Special Bulletin

SP16-316C

Rev C: This revision replaces all previous releases
July 19, 2016 Crack repair details added / Cosmetics in IT50004

FUEL TANK FRAME FRONT SUPPORT WELD

10. Welding Fillet dimension is 3mm (1/8") everywhere. (Fig. 6 & 7)

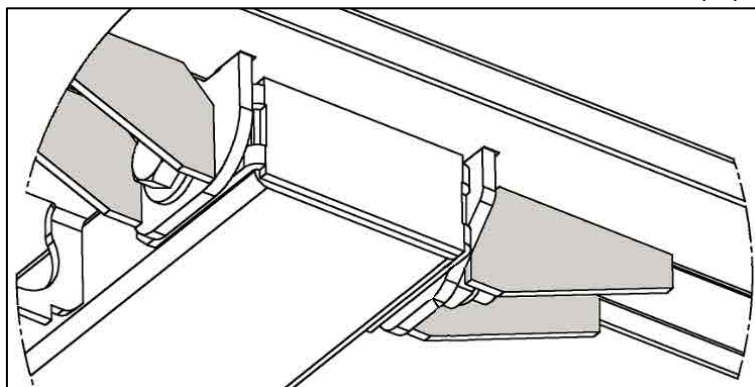
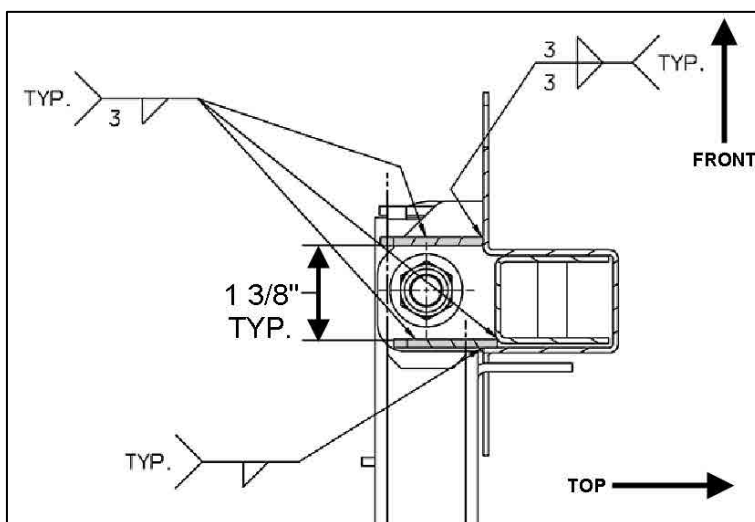
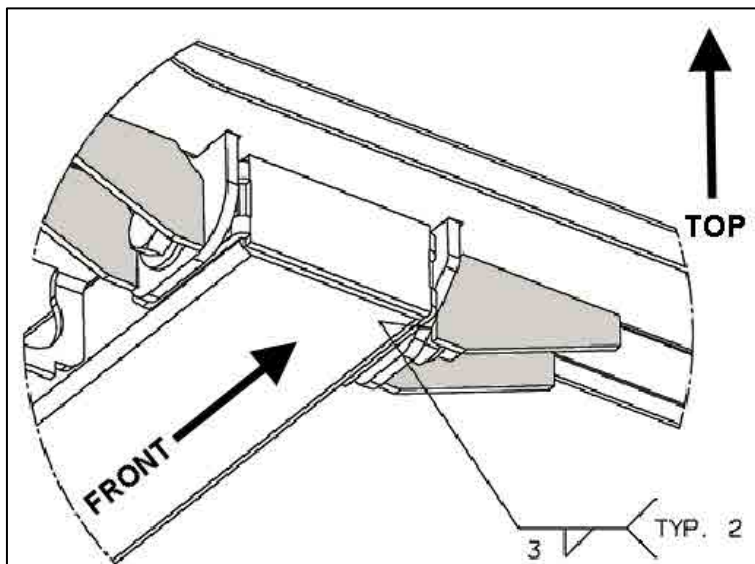
8. Four gussets #240036 will be added on the existing ears, on both sides. (Fig. 4)

Perform welding according to procedure in *Appendix D*.

All Weld must meet IT750004 requirement in *Appendix C*.
